MEMORANDUM

From: Devin E. Simpson, P.E.
Kimley-Horn and Associates, Inc.

Date: October 7, 2026

Subject: Carrsbrook Drive – Commercial Driveway Sight Distance Assessment

Impacts of Vertical Curvature

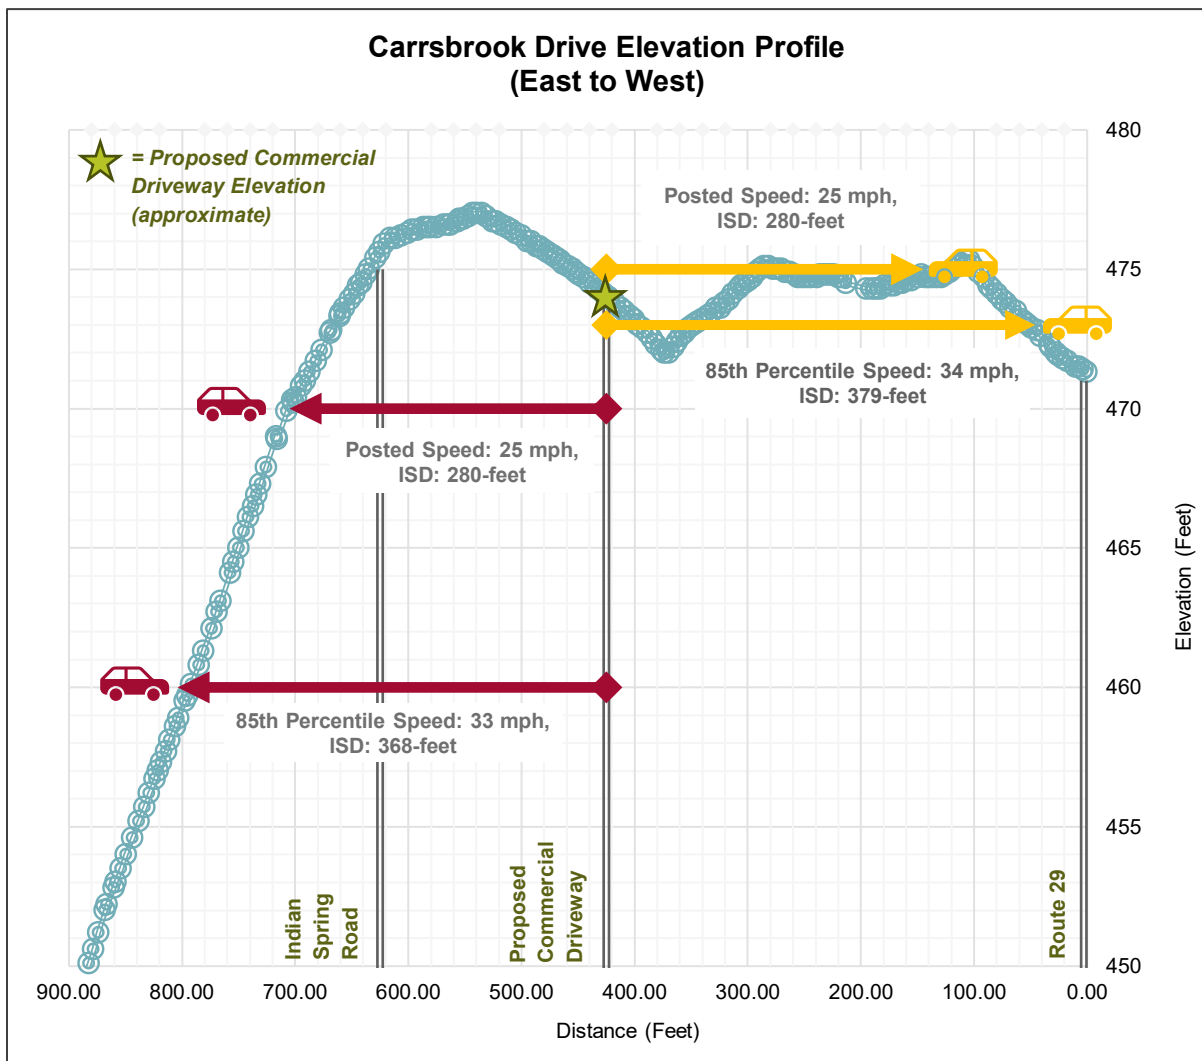
Carrsbrook Drive within the vicinity of the project location has variances in the vertical curvature, or grade, of the roadway. While vertical sight lines cannot be fully assessed as part of this desktop review, elevations were obtained from Google Earth to understand the potential impact that existing grades may have on intersection sight distance. Additionally, the proposed commercial entrance elevations are not known, and could be higher or lower than the existing edge of pavement, which would impact actual intersection sight distance. The elevation profile is shown in **Figure 4**. Based on this preliminary assessment, vertical sight lines for looking to the right or west, known as sight distance right (SDR), appear to be adequate. However, vertical sight lines for left- and right-turning vehicles, looking to the left or east—known as sight distance left (SDL)—appears inadequate at the posted and 85th percentile speed due to the vertical curvature of the roadway.

Based on this limited sight distance assessment, it is recommended that further consideration be given to the appropriateness of the proposed commercial driveway location as meeting intersection sight distance requirements is important for the safety of the traveling public. Where currently located, the driveway appears to meet intersection distance requirements at the posted speed limit of 25 mph for horizontal sight lines and vertical sight lines only when looking west. ***However, intersection sight distance for right-turning and left-turning traffic looking left or east prior to turning appears inadequate at 25 mph and the 85th percentile speed based on the vertical curvature of the roadway.***
